ANN ARBOR HISTORIC DISTRICT COMMISSION

Staff Report

ADDRESS: 808 W Washington Street Application Number: HDC24-0188

APPLICATION: The applicant seeks HDC approval to rebuild a non-historic mudroom on the rear of the house in a footprint that is 24 square feet larger; construct a 23-foot-wide shed dormer on the south roof surface; and construct a 27'2" x 27'7" garage with a second floor accessory dwelling unit (ADU).

A-4

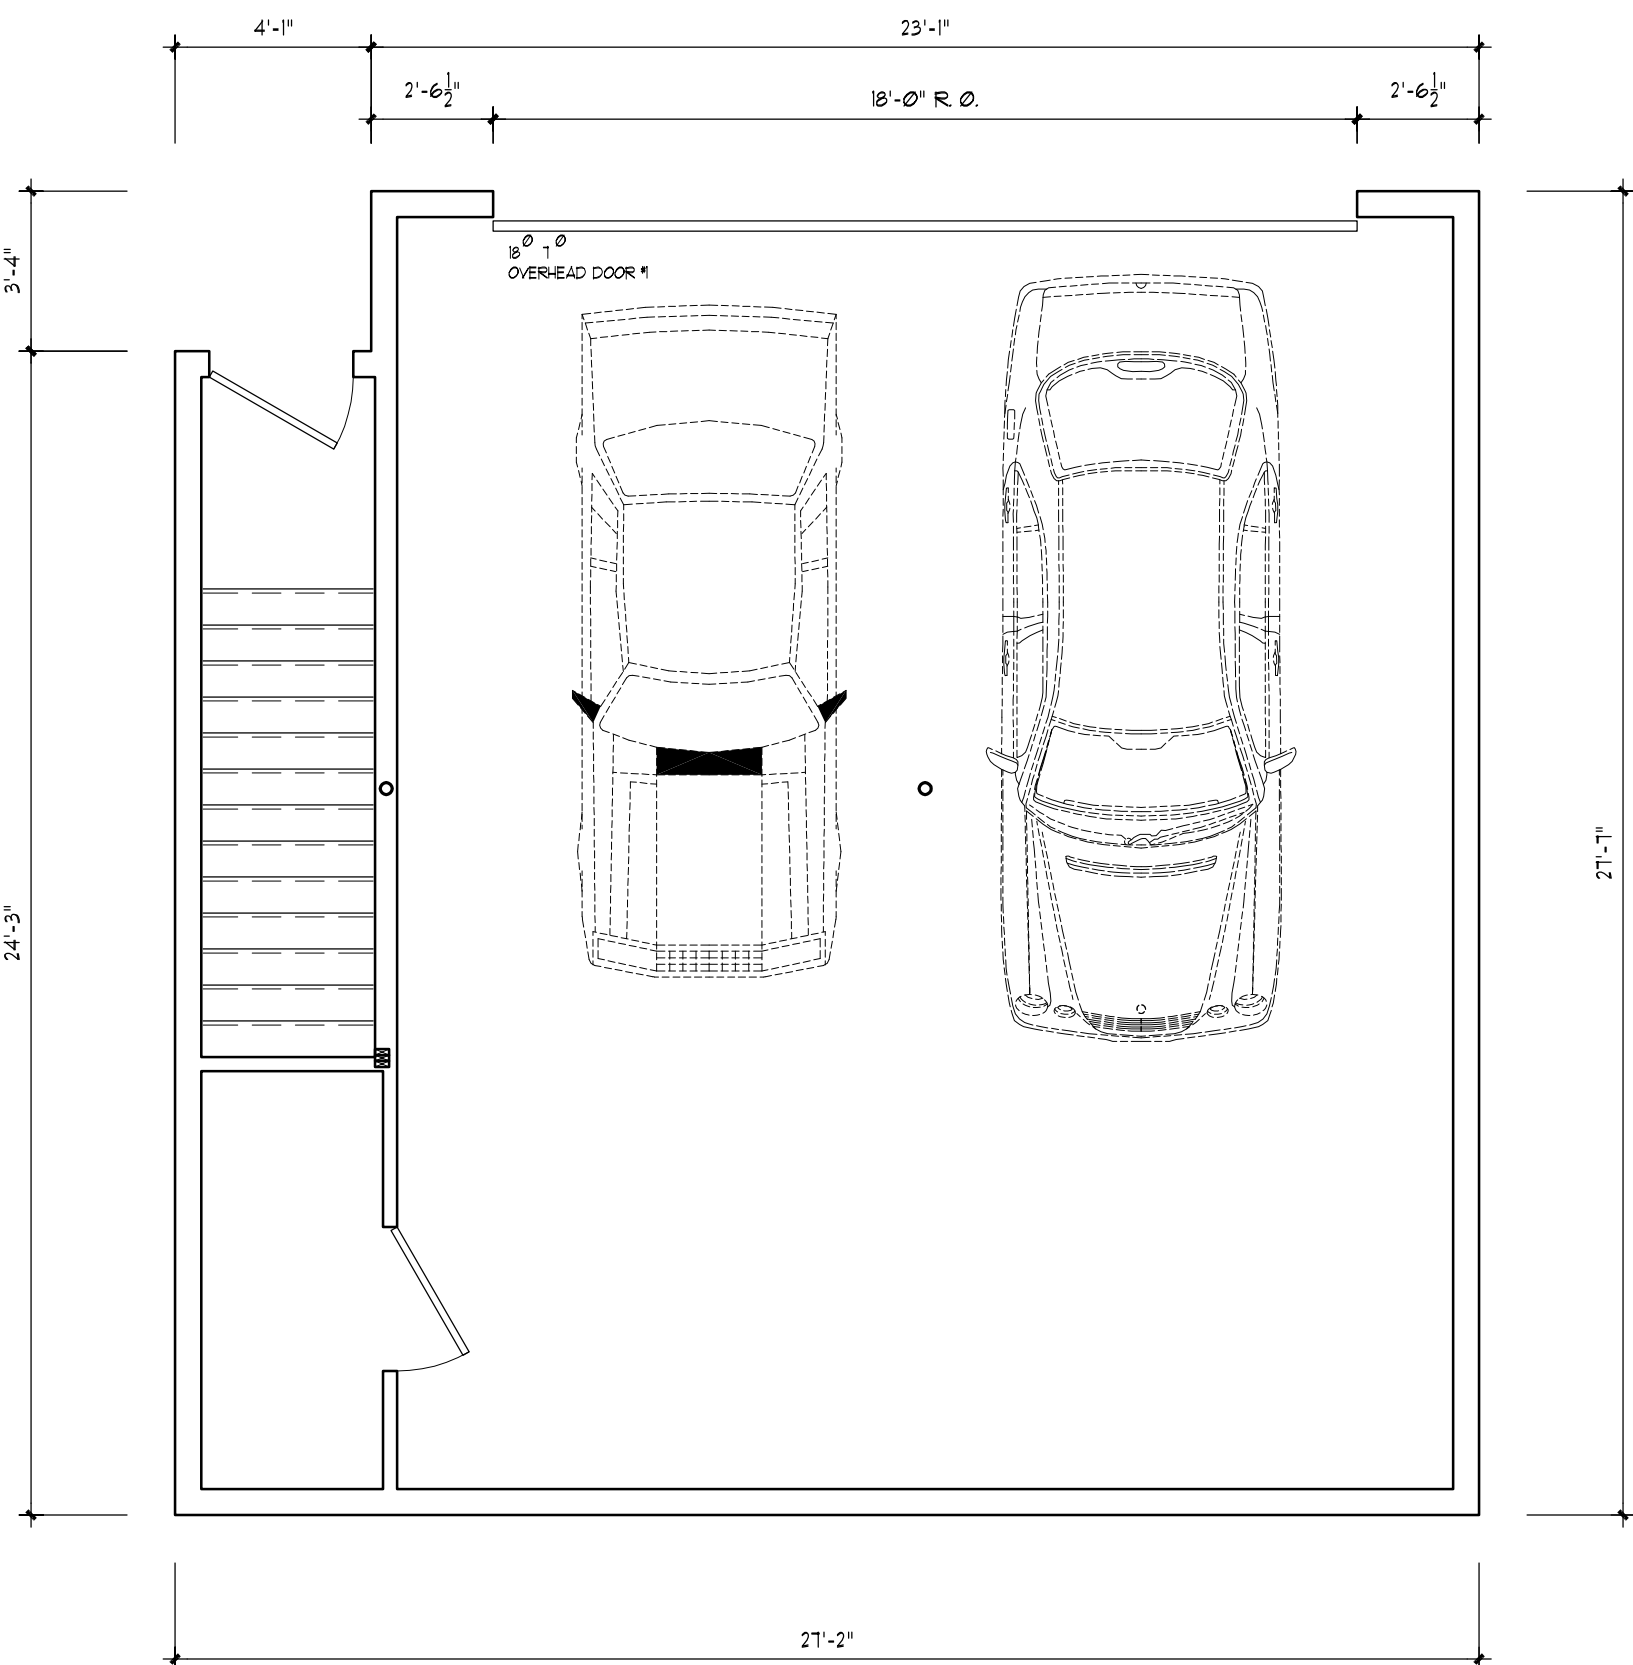
1. **Windows.** The window casings and sills for all new window openings on the mudroom and dormer will be differentiated from the existing as described in the window notes on sheet A-4. New windows on the house and garage/ADU are Marvin aluminum clad. Window profiles are provided in the attachments.

GARAGE
PLANS
and
NOTES

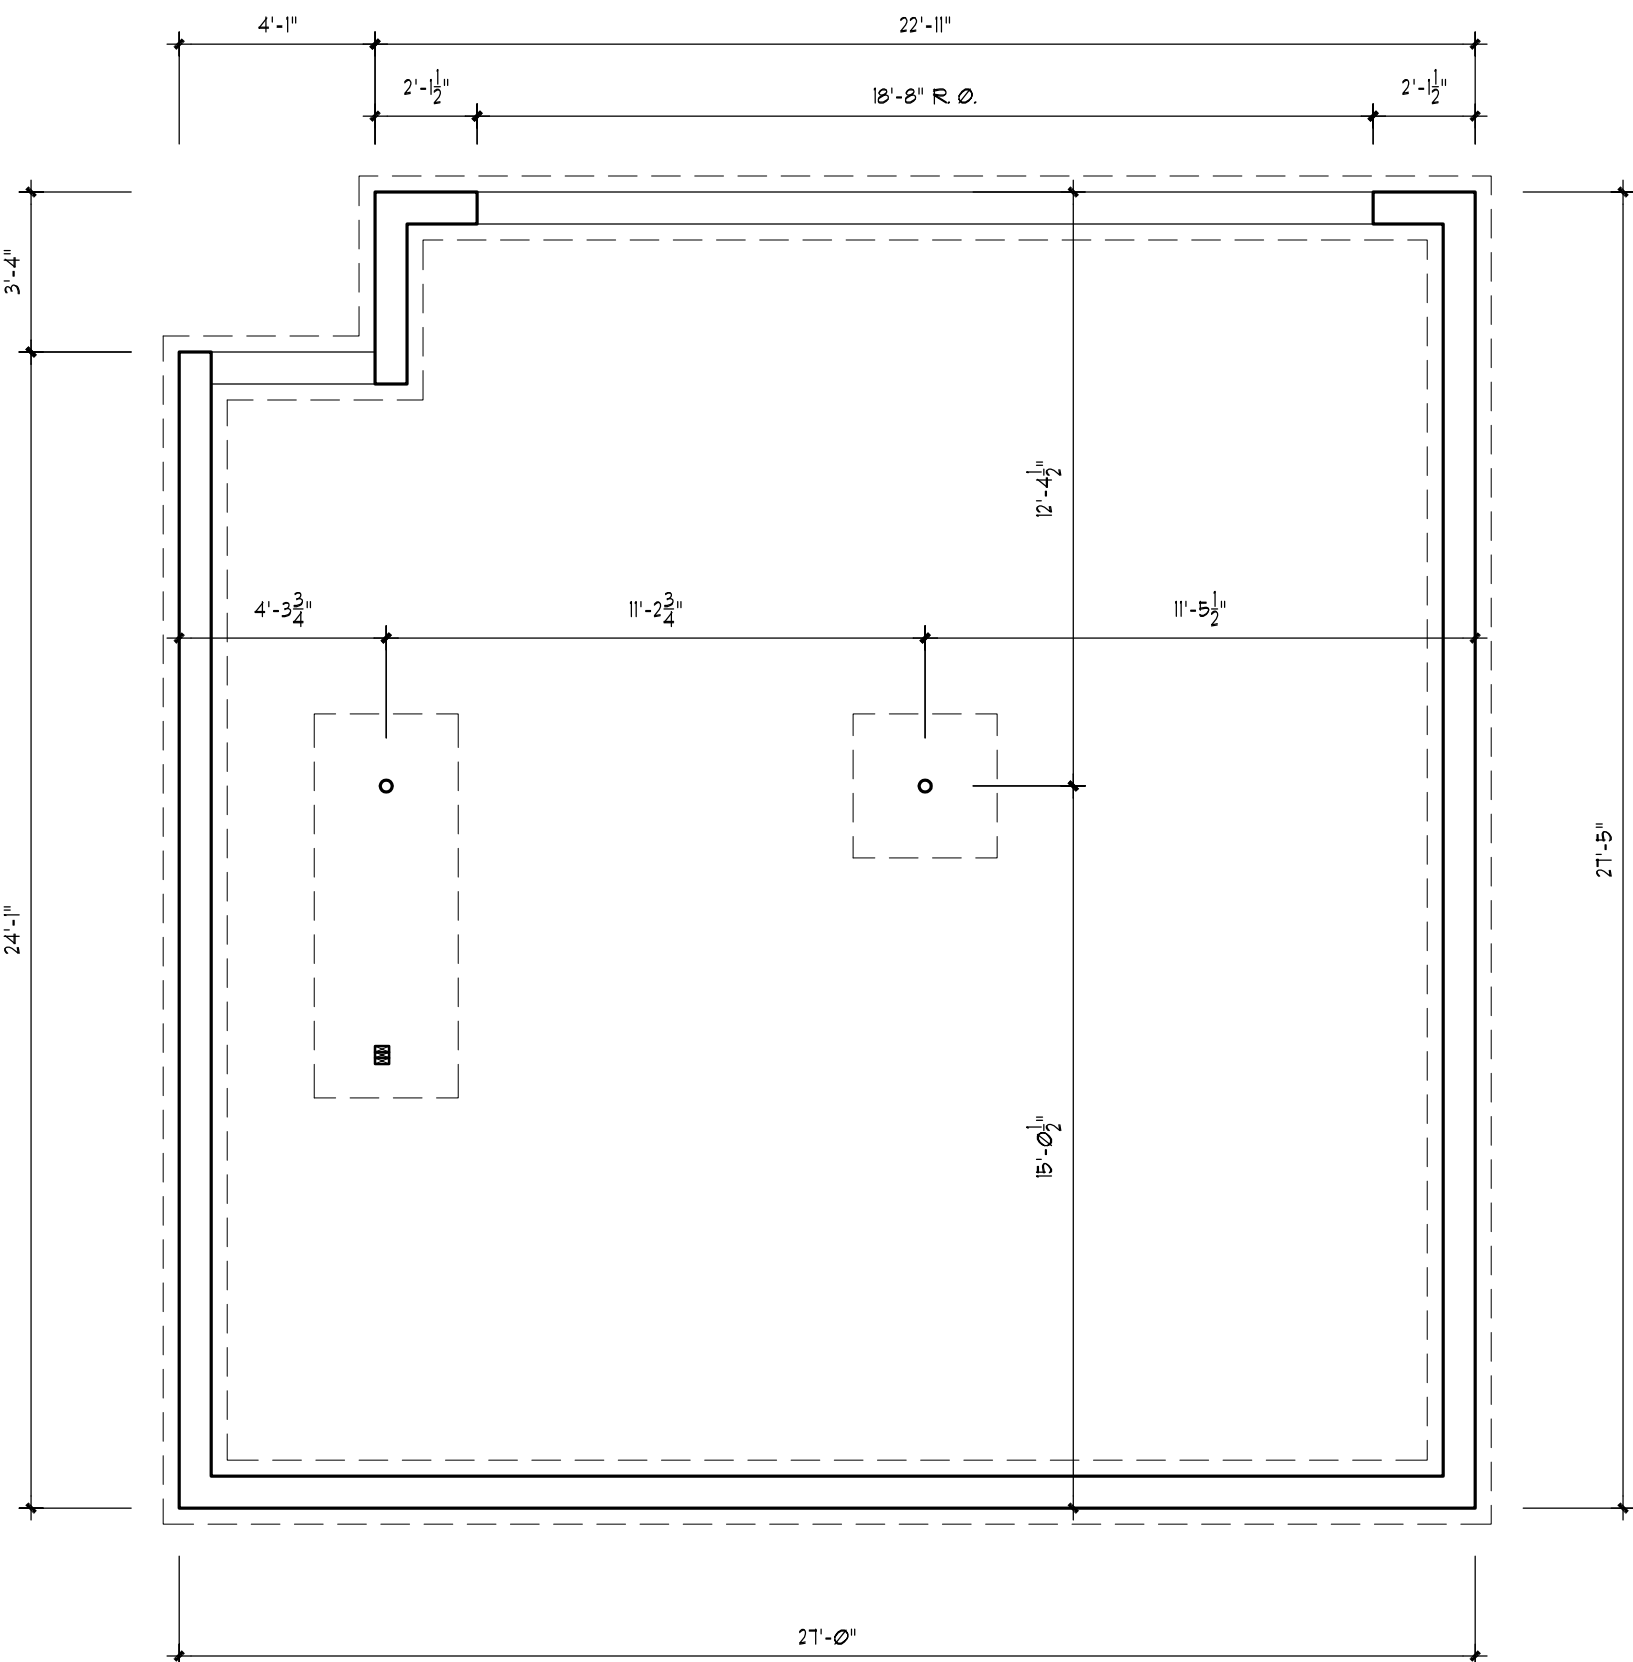
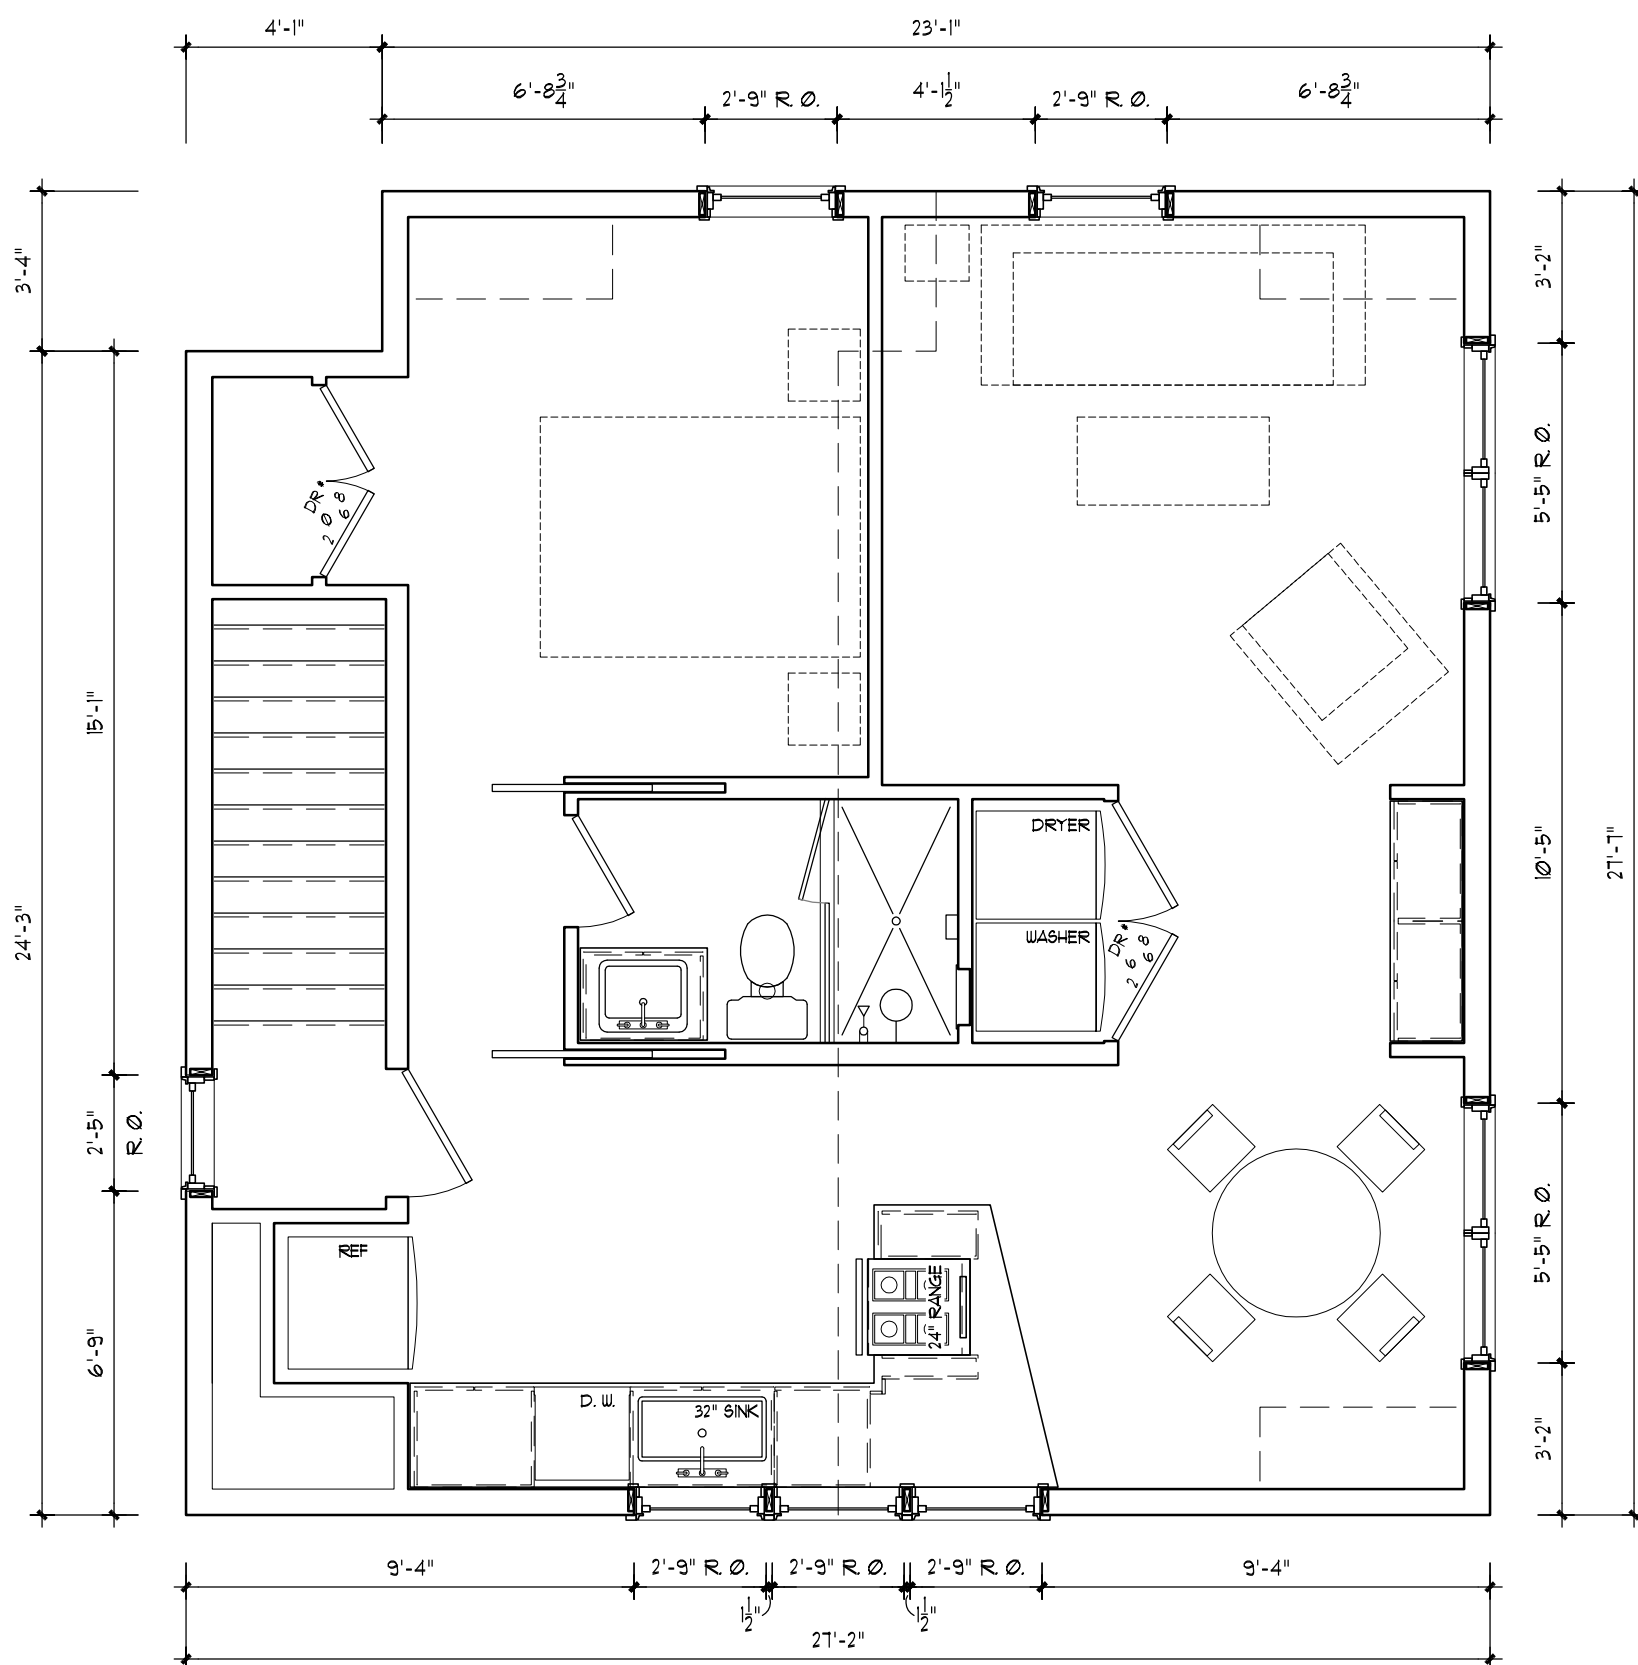
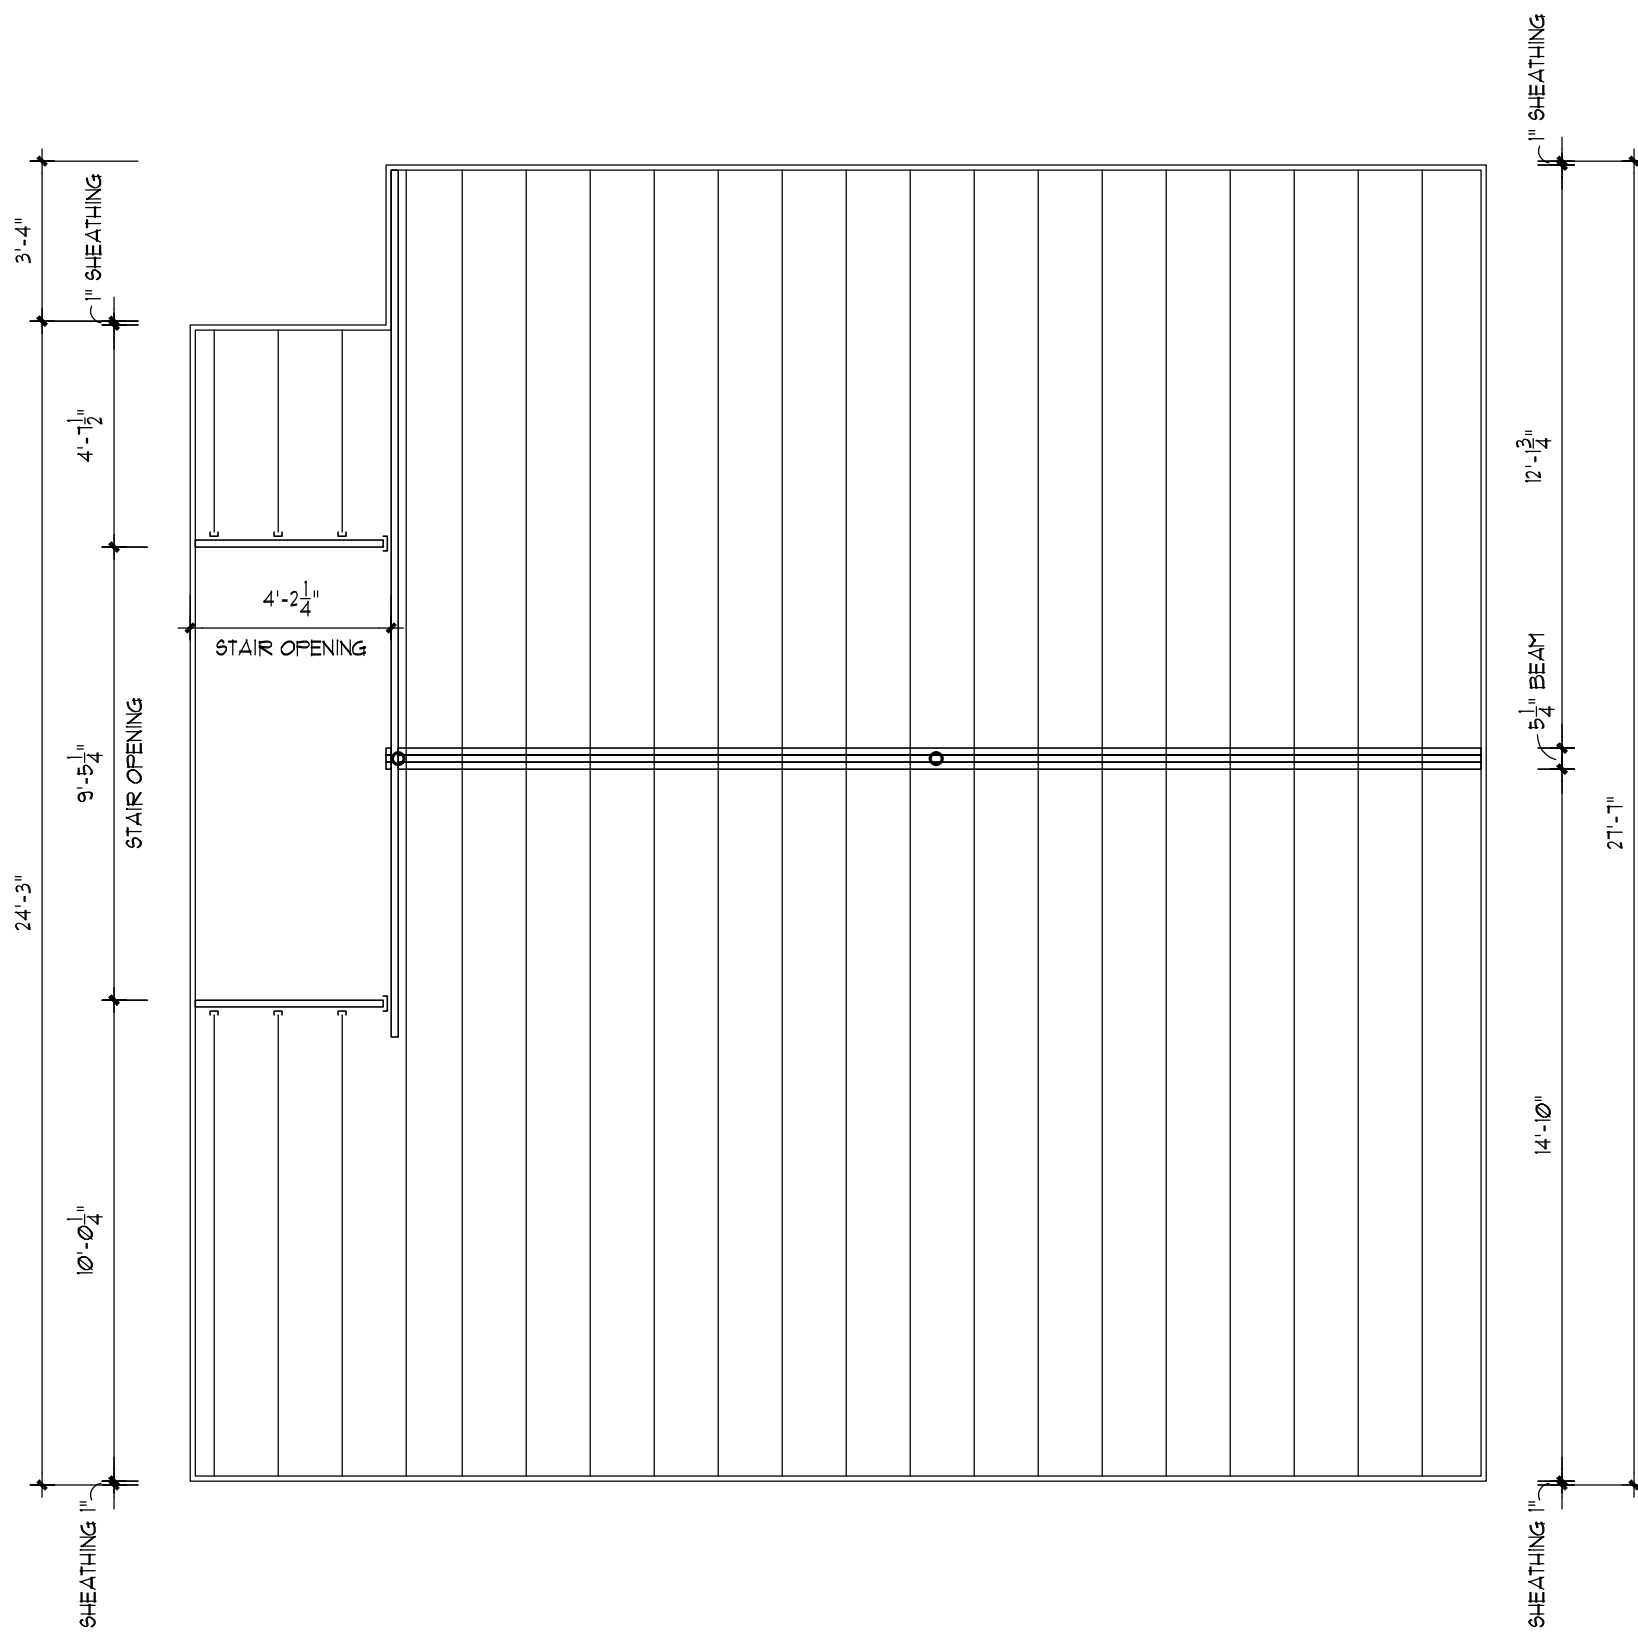
8. The garage has a 736 square foot footprint, with an accessory dwelling unit of the same size upstairs, for a total of 1472 square feet. This is very large for an accessory structure, though staff believes it is compatible with other garages and a large barn in the vicinity. The building is 1 3/4 stories with a ridge height of 26' 3". The zoning maximum height of 21' to the midpoint of the gable is not labeled, but this appears to comply. The foundation is slab on grade with concrete masonry unit trench footings. The garage has a two-car overhead door and a person door on the north elevation which accesses only stairs to the ADU. Materials for the overhead door and person door are not specified. This north elevation has two upper floor casement windows. The south elevation facing the house has a triple awning window and shed dormers on each side with single or paired
